GRANITE · FIRST CRACK

A-40-1-1091 · PLAN 09 · 81 markups in the list
Page 3 is a glance of the same list if you open this PDF without Revu.
NEED = missing info. CHECK = a note. OTHER = not this sheet.

NY VÅRDBYGGNAD

FLYGEL A - PLAN 09, DEL 1
PLANRITNINGAR

FASTIGHETSNUMMER	NUMMER	BET
0001	A-40-1-1091

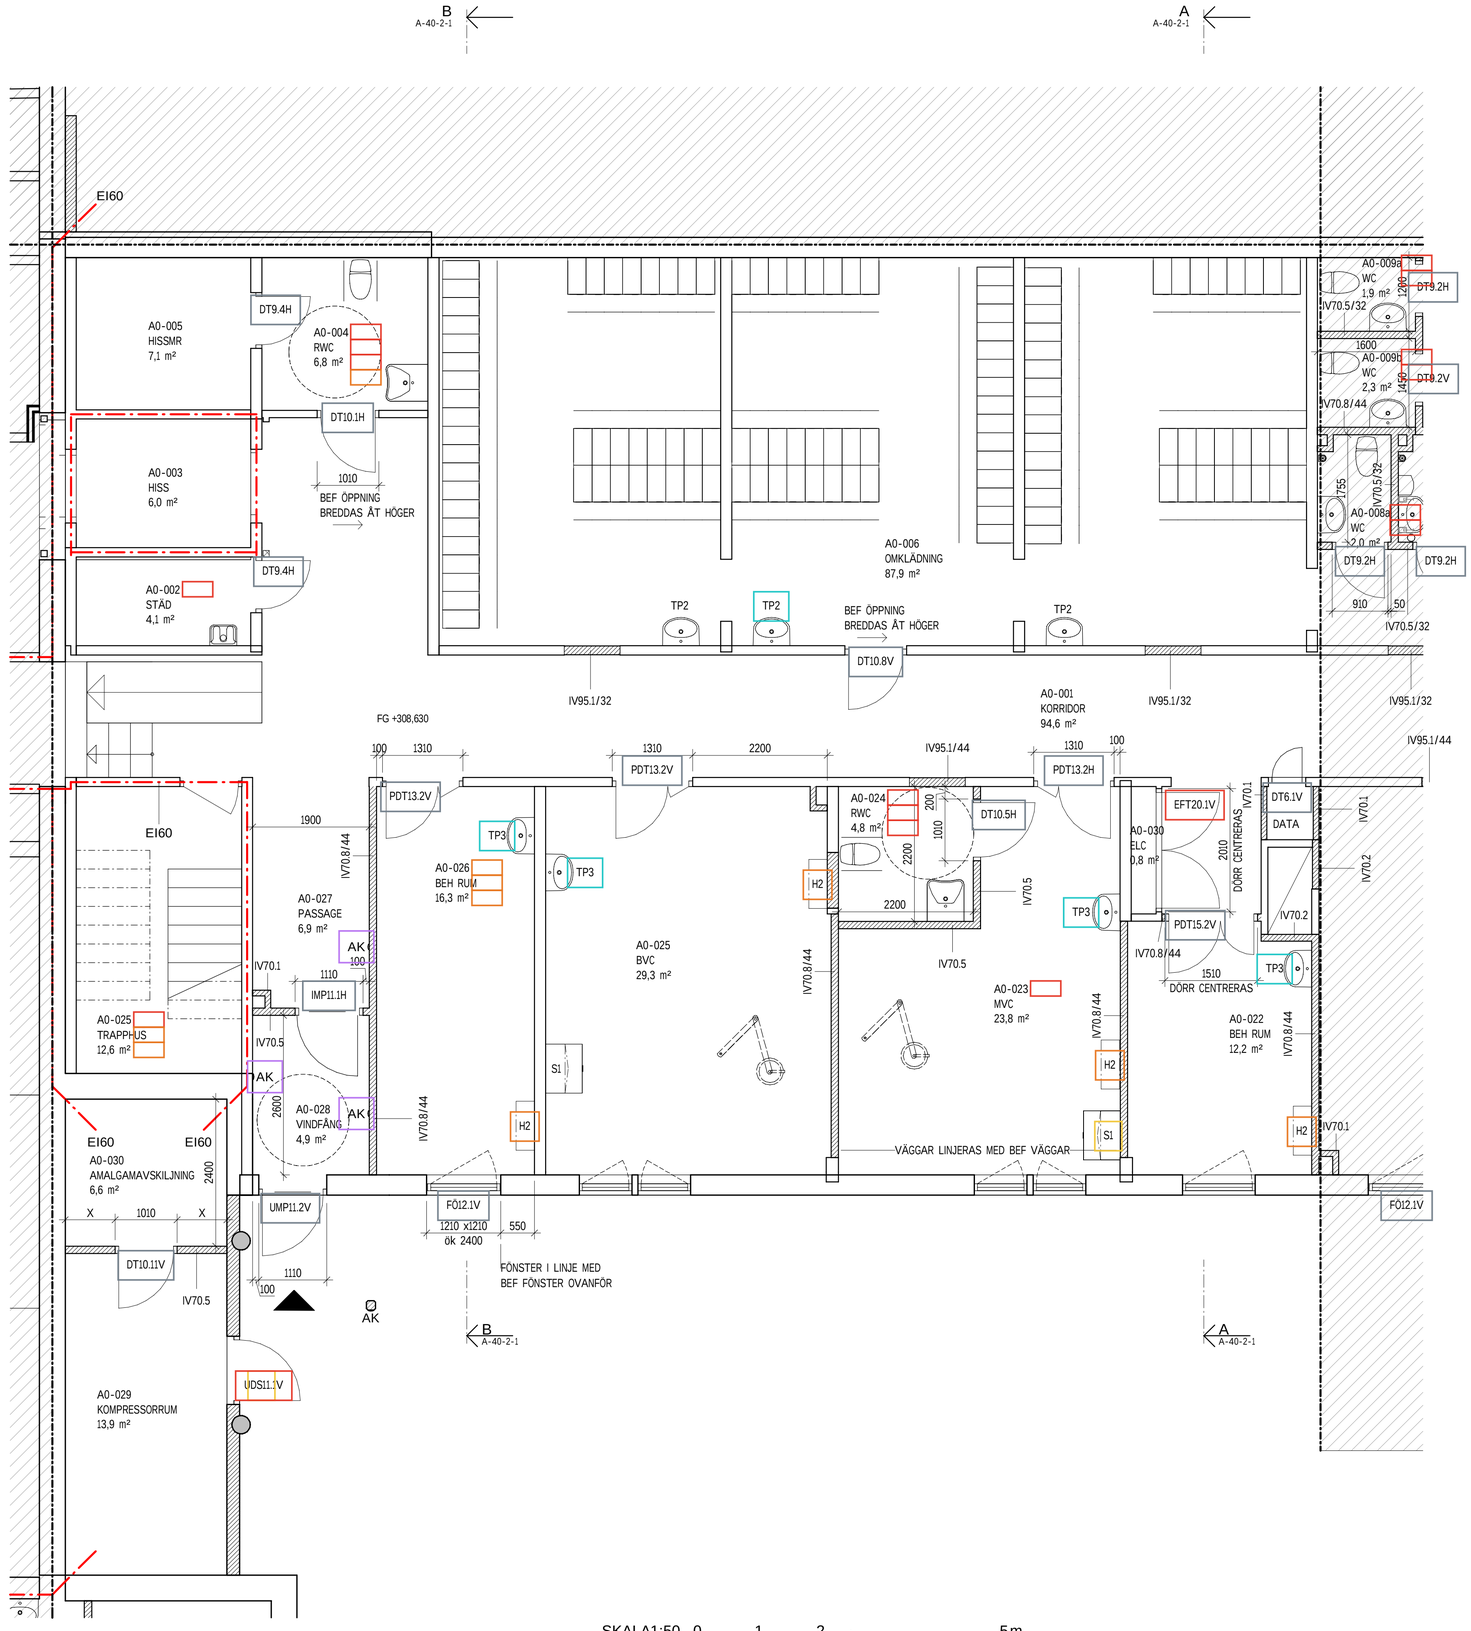
Subject	Flag	Qty	Room	Comment	What is missing / note
EFT20.1V	NEED	1	A0-030	EFT20.1V, ELC; description unavailable	The draft has a mark but no product type. Do not invent an article.
H2	NEED	1	A0-022	Hylla H2; length and specification unavailable	The floor plan marks the shelf. Length and spec are on the room description · that file
H2	NEED	1	A0-023	Hylla H2; length and specification unavailable	The floor plan marks the shelf. Length and spec are on the room description · that file
H2	NEED	1	A0-025	Hylla H2; length and specification unavailable	The floor plan marks the shelf. Length and spec are on the room description · that file
H2	NEED	1	A0-026	Hylla H2; length and specification unavailable	The floor plan marks the shelf. Length and spec are on the room description · that file
NEED	NEED	1	A0-002	Utslagsback	A sanitary symbol is drawn, but there is no type code. Need the setting-out / type stand

NEED	NEED	2	A0-004	Stödarm	A sanitary symbol is drawn, but there is no type code. Need the setting-out / type stand
NEED	NEED	1	A0-004	Tvättställ	A sanitary symbol is drawn, but there is no type code. Need the setting-out / type stand
NEED	NEED	1	A0-004	WC-stol	A sanitary symbol is drawn, but there is no type code. Need the setting-out / type stand
NEED	NEED	1	A0-008a	Tvättställ	A sanitary symbol is drawn, but there is no type code. Need the setting-out / type stand
NEED	NEED	1	A0-008a	WC-stol	A sanitary symbol is drawn, but there is no type code. Need the setting-out / type stand
NEED	NEED	1	A0-009a	Tvättställ	A sanitary symbol is drawn, but there is no type code. Need the setting-out / type stand
NEED	NEED	1	A0-009a	WC-stol	A sanitary symbol is drawn, but there is no type code. Need the setting-out / type stand
NEED	NEED	1	A0-009b	Tvättställ	A sanitary symbol is drawn, but there is no type code. Need the setting-out / type stand

NEED	NEED	1	A0-009b	WC-stol	A sanitary symbol is drawn, but there is no type code. Need the setting-out / type stand
NEED	NEED	1	A0-023	Unidentified articulated arm with circular head; product type to be confirmed	The draft has a mark but no product type. Do not invent an article.
NEED	NEED	2	A0-024	Stödarm	A sanitary symbol is drawn, but there is no type code. Need the setting-out / type stand
NEED	NEED	1	A0-024	Tvättställ	A sanitary symbol is drawn, but there is no type code. Need the setting-out / type stand
NEED	NEED	1	A0-024	WC-stol	A sanitary symbol is drawn, but there is no type code. Need the setting-out / type stand
NEED	NEED	1	A0-025	Unidentified articulated arm with circular head; product type to be confirmed	The draft has a mark but no product type. Do not invent an article.
NEED	NEED	1	·	Tvättställ, partially shown east of A0-008a	A sanitary symbol is drawn, but there is no type code. Need the setting-out / type stand

NEED	NEED	1	·	WC-stol, partially shown east of A0-008a	A sanitary symbol is drawn, but there is no type code. Need the setting-out / type stand
S1	NEED	1	A0-023	S1; description unavailable	The draft has a mark but no product type. Do not invent an article.
S1	NEED	1	A0-025	S1; description unavailable	The draft has a mark but no product type. Do not invent an article.
TP2	NEED	3	A0-006	TVÄTTPLATSUTRUSTNING	This is a package code. What is inside it comes from the type standard, which is not in
TP3	NEED	1	A0-022	TVÄTTPLATSUTRUSTNING	This is a package code. What is inside it comes from the type standard, which is not in
TP3	NEED	1	A0-023	TVÄTTPLATSUTRUSTNING	This is a package code. What is inside it comes from the type standard, which is not in
TP3	NEED	1	A0-025	TVÄTTPLATSUTRUSTNING	This is a package code. What is inside it comes from the type standard, which is not in
TP3	NEED	1	A0-026	TVÄTTPLATSUTRUSTNING	This is a package code. What is inside it comes from the type standard, which is not in

UDS11.1V	NEED	1	A0-029	UDS11.1V, KOMPRESSORRUM; description unavailable	The draft has a mark but no product type. Do not invent an article.
CHECK	CHECK	·	·	10 lines have no room (hatches, match-line items, one elbow tap).	Verify before you sign.
CHECK	CHECK	·	·	17 lines have no type code (WC, basin, support arms, unidentified arms).	Verify before you sign.
CHECK	CHECK	·	·	All 69 API lines are in this draft. The six recovered lines are other-floor request shelves.	Noted.
CHECK	CHECK	·	·	Doors, windows and metal frames are in the draft but kept out of the customer basket (other	Noted.
CHECK	CHECK	·	·	H2 is drawn, but length is not on this floor plan.	Verify before you sign.
CHECK	CHECK	·	·	Hatch quantities come from a table on the sheet, not from counting rooms.	Verify before you sign.
CHECK	CHECK	·	·	Only this PDF was uploaded. Ten other drawings, the room description and the type standard a	Verify before you sign.

CHECK	CHECK	·	·	Request-only shelves stay out of this basket: 4× H1, 8× H2, 1× H3 (A0-015). They stay on the	Noted.
CHECK	CHECK	·	·	S1, EFT20.1V, UDS11.1V and two articulated arms have no product type.	Verify before you sign.
CHECK	CHECK	·	·	TP3 / TP2 are package codes. Contents need the type standard.	Verify before you sign.
CHECK	CHECK	·	·	The customer asked for H2. The old specialist quote never listed H2.	Verify before you sign.
CHECK	CHECK	·	·	The four H2 rooms in the email are on this plan (A0-022, 023, 025, 026).	Noted.
AK	On sheet	1	A0-027	ARMBÅGSKONTAKT	Elbow tap is drawn. Confirm article and whether it belongs in this fittings quote.
AK	On sheet	2	A0-028	ARMBÅGSKONTAKT	Elbow tap is drawn. Confirm article and whether it belongs in this fittings quote.
AK	On sheet	1	·	ARMBÅGSKONTAKT outside entrance	Elbow tap is drawn. Confirm article and whether it belongs in this fittings quote.
IL.4	On sheet	2	·	HILA Inspektionslucka 300x300 mm	From the hatch table on this sheet, not counted on the floor.
